<b>Form 504</b> U. S. DEPARTMENT OF COMMERCE COAST AND GEODETIC SURVEY  <b>DESCRIPTIVE REPORT</b>	
<i>Type of Survey</i> Hydrographic	
<i>Field No.</i> LJ-5-1-61 <i>Office No.</i> H-8620	
<b>LOCALITY</b>	
<i>State</i> S. E. Alaska	
<i>General locality</i> Wrangell Island	
<i>Locality</i> Wrangell Harbor	
<u>19 61</u>	
<b>CHIEF OF PARTY</b>	
L. G. Tyalor	
<b>LIBRARY &amp; ARCHIVES</b>	
<b>DATE</b>	July 13, 1962

REVIEW OF HYDROGRAPHIC SURVEY

REGISTRY NO. H-8620

S.E. Alaska, Wrangell I., Wrangell Harbor

Correction to C. & G. S. Chart 8164

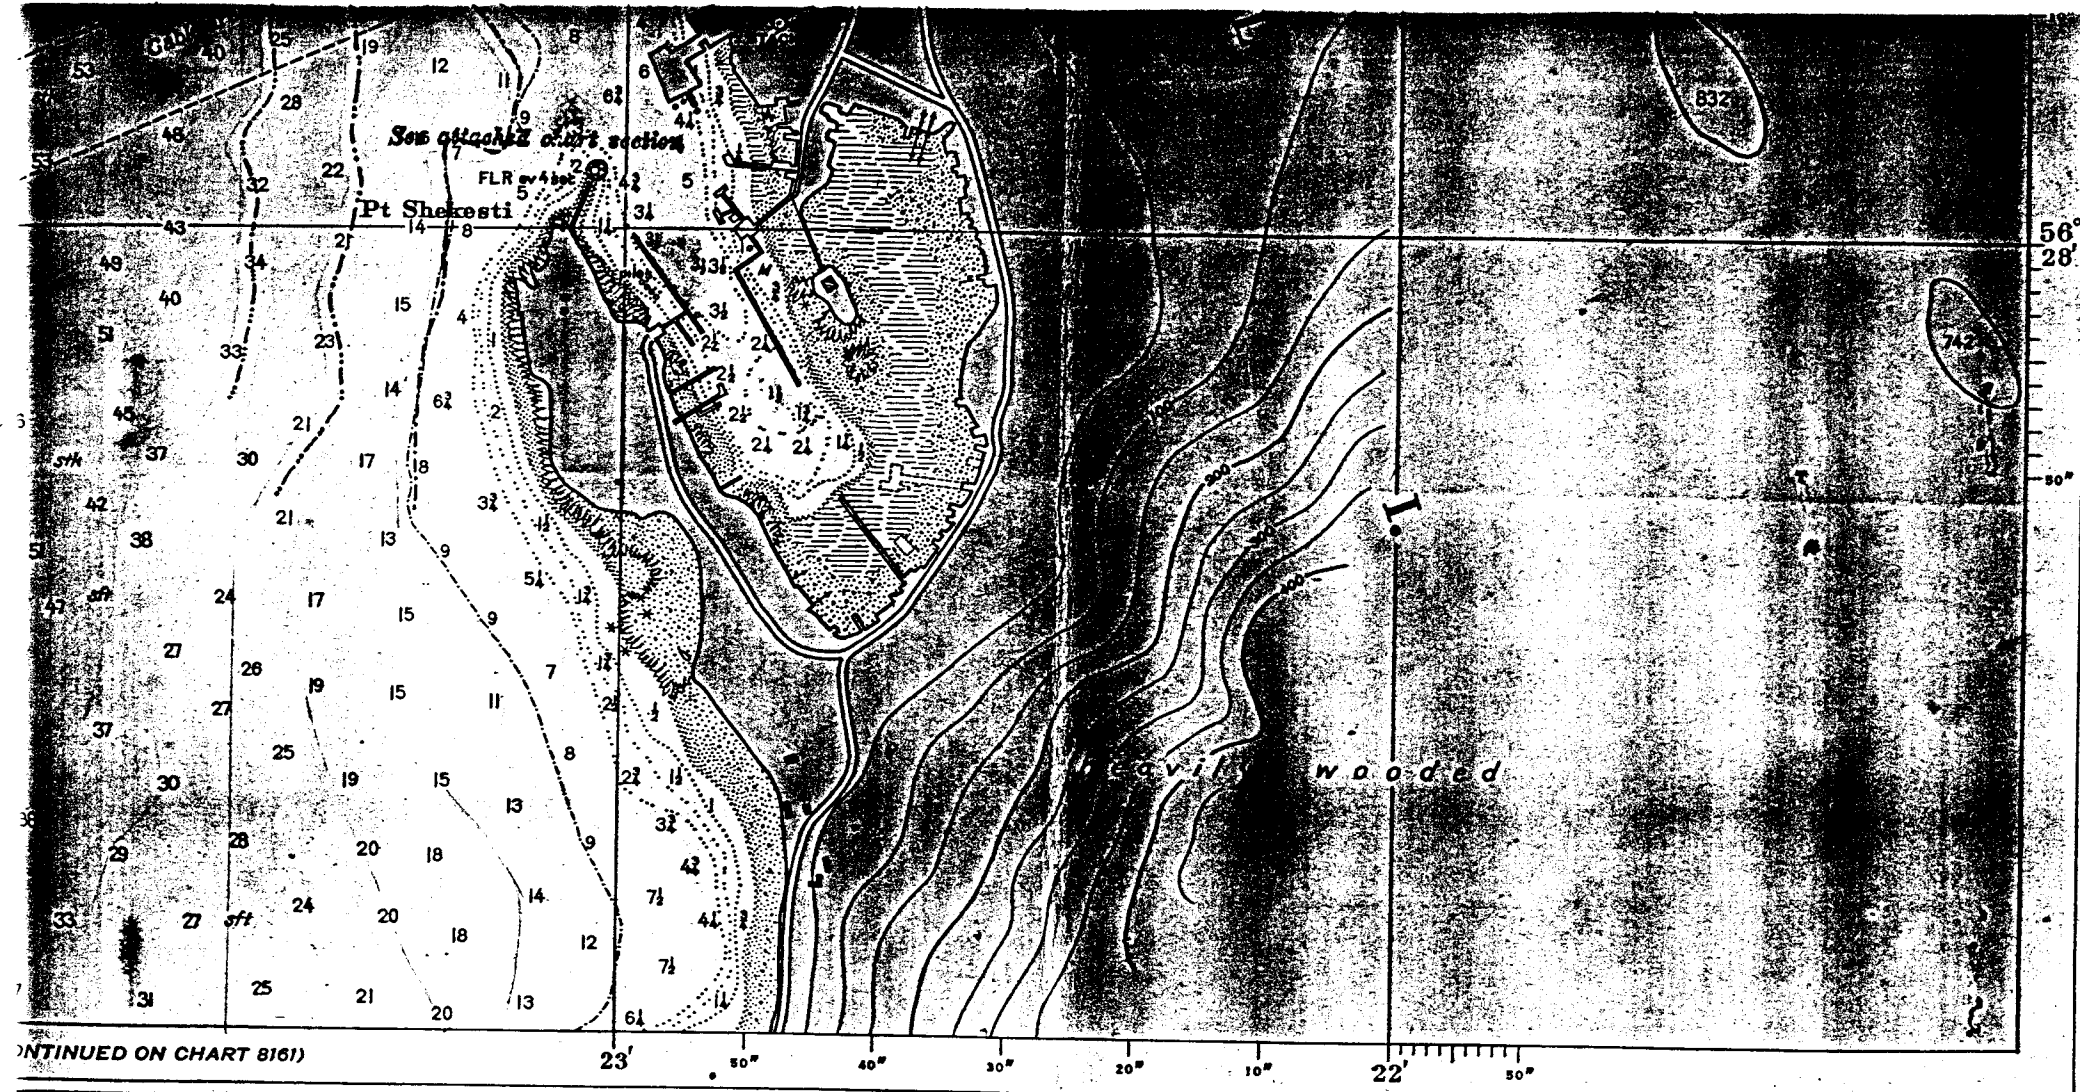
This survey compared with Chartlet N.M.4, dated January 27, 1962, attached to Chart 8164, 4th Ed., dated June 2, 1952, and the chart. The soundings on the smooth sheet are generally slightly deeper than those of the boat sheet, from which the soundings for the chartlet were taken. The soundings on the Chart, outside of the area of the chartlet, appear generally deeper than this survey. There is also some shoreline change. ✓  
P7A  
Review

See section of Chart 8164 and Chartlet attached to this report for comparison. ✓

7. Comparison with Drawing No. 5 of Chart 8164  
(Corrections applied to print of 6-2-52)

The charted hydrography originates with H-6282(1937) previously discussed which needs no further consideration and the boat sheet (Bp 61593) of the present survey. The charted depths are in adequate agreement with the present survey.

The present survey supersedes the charted hydrography within the common area.

The charted positions of the aids to navigation originate with the present survey and adequately mark the features intended.

The charted controlling depths in Wrangell Harbor originate with the boat sheet (Bp 61593) of the present survey. The charted controlling depths here are in agreement with the present survey depths after verification and review.
